**REQUEST FOR FURTHER INFORMATION #2 - PRIVATE PLAN CHANGE 29 -  
SUMMERSET VILLAGES (RANGIORA) LIMITED, 141 SOUTH BELT, RANGIORA**

We set out below in tabular form, a set of responses to each of the points you raised in your letter:

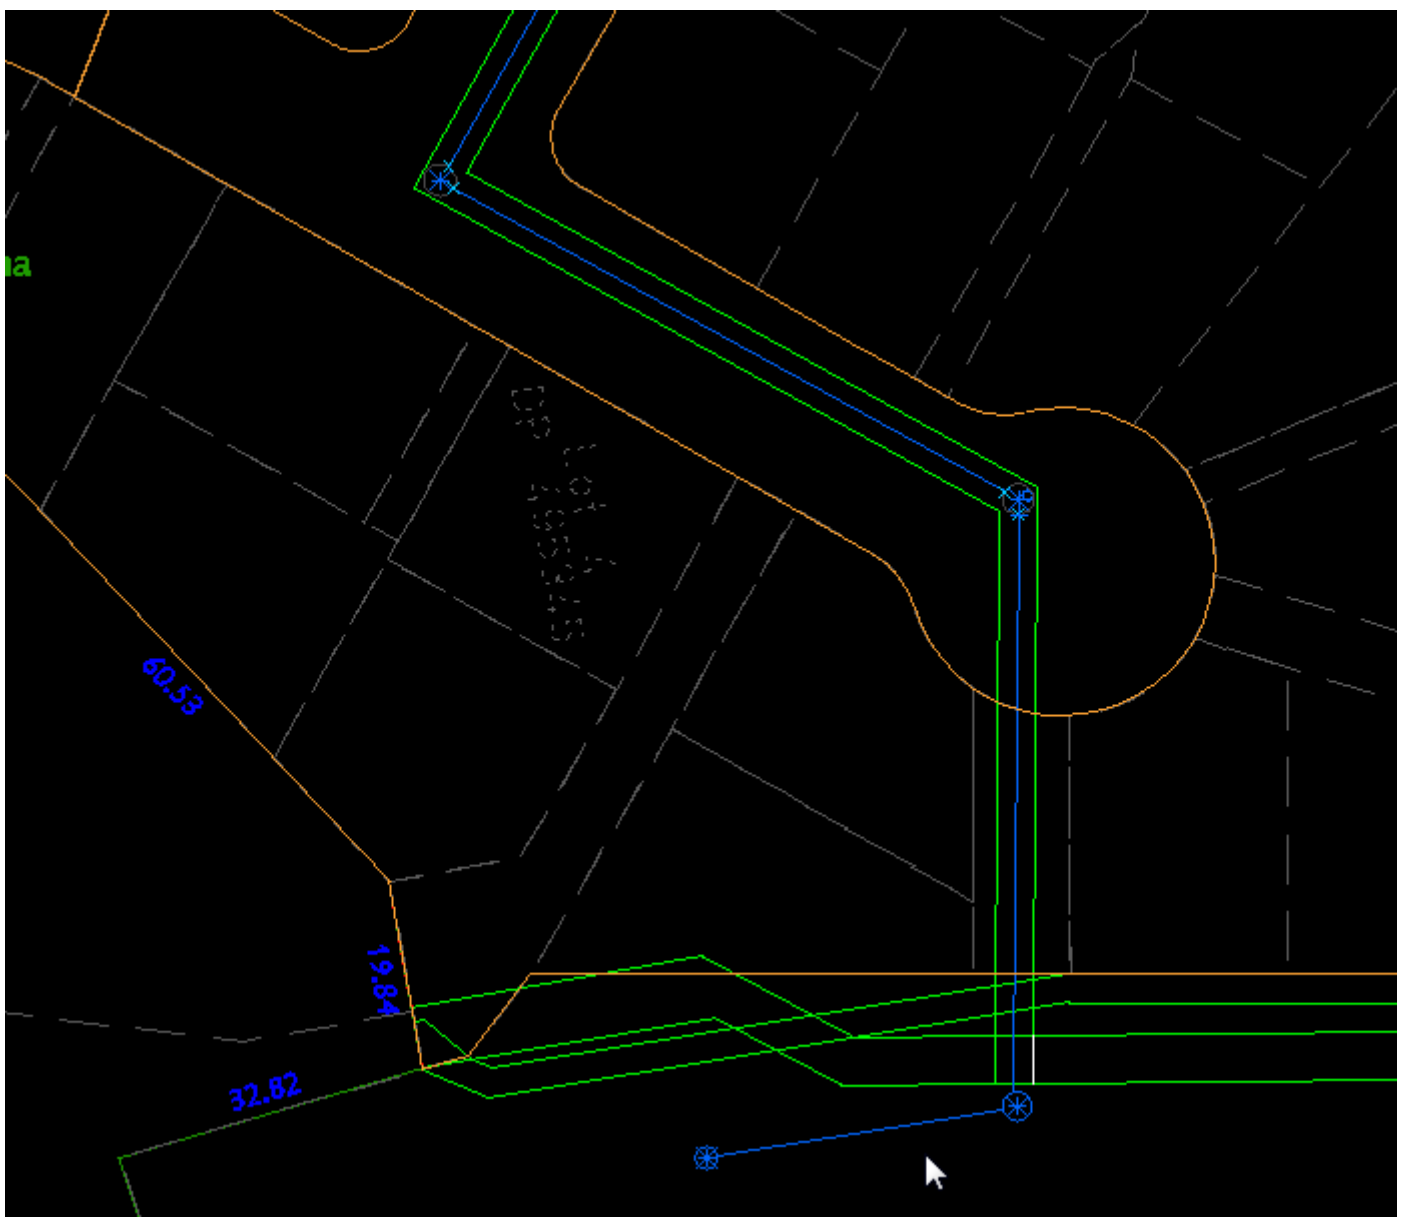
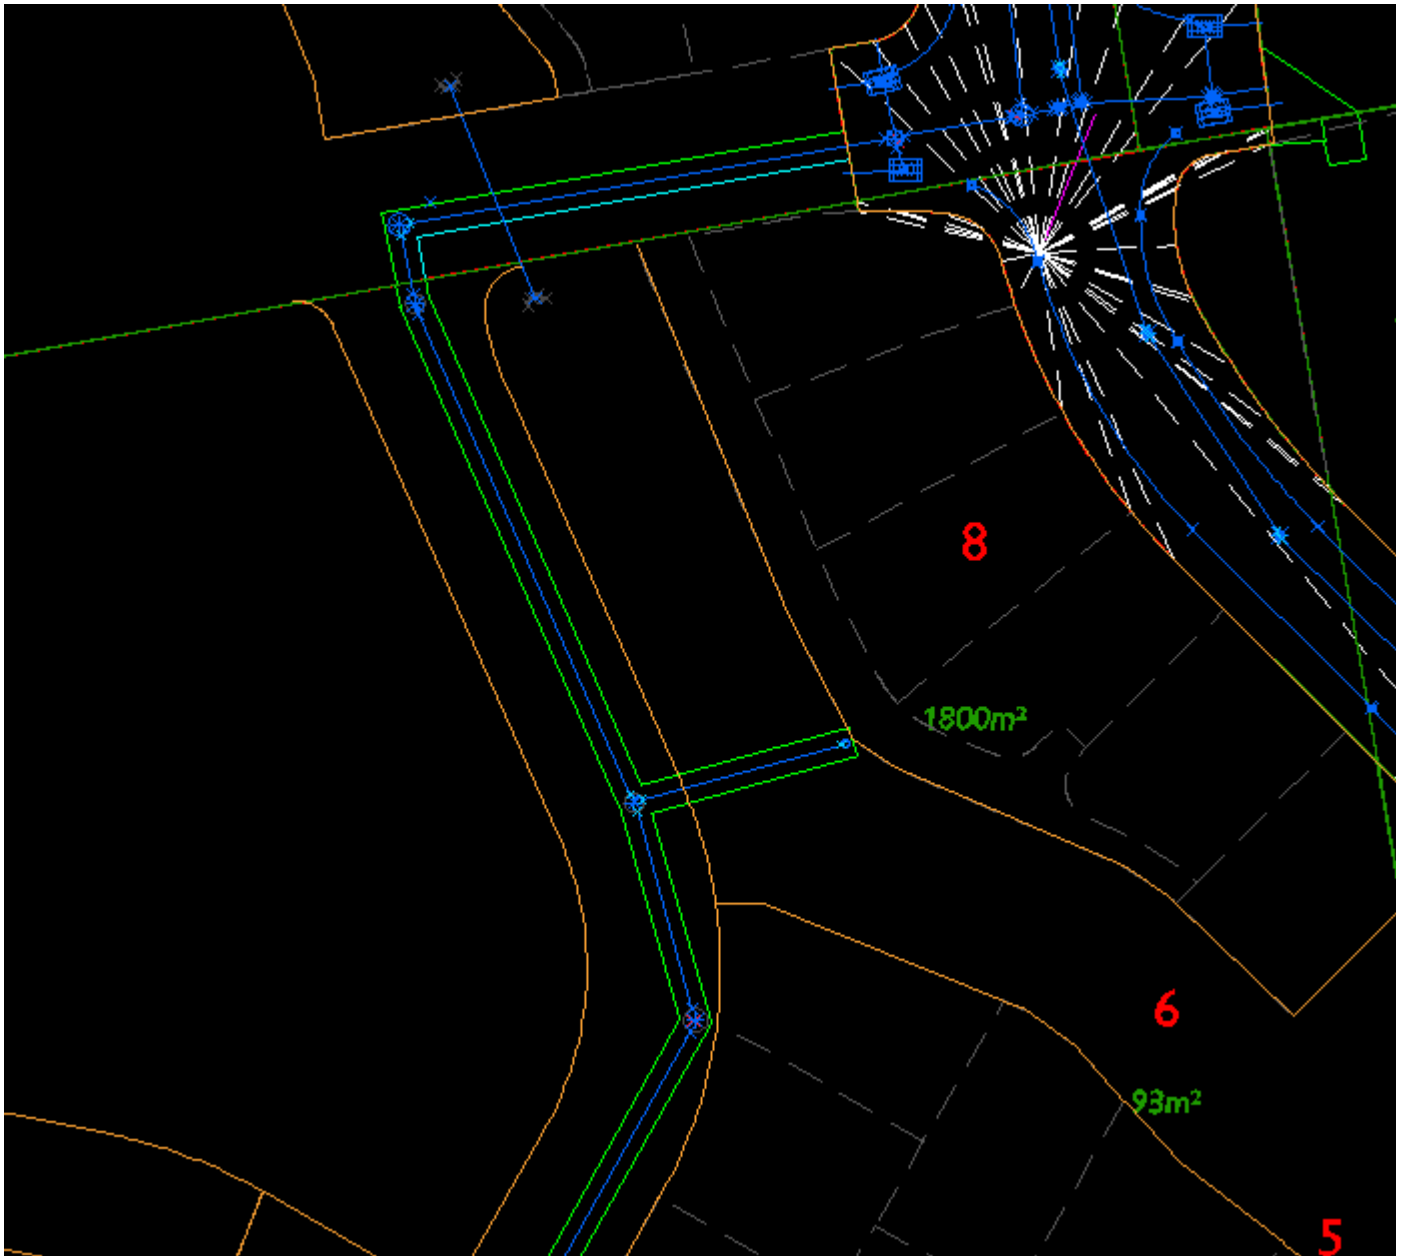
8. The approved application plan states *“Extra easements for right to drain water in gross in favour of Waimakariri District Council will be created on the Land Transfer Plan once as built positions of engineering works are available.”* These additional easements do not appear to have been added and as built have not been provided to confirm the location of easements if required.

These easements have now been captured and are shown as easements D, F, G & H. I have included a few screen dumps showing the asbuilt location of the stormwater infrastructure around the newly created easements. The asbuilt plans are currently going through the QA checks and a final copy will be sent to Council as part of the upcoming s224 application.
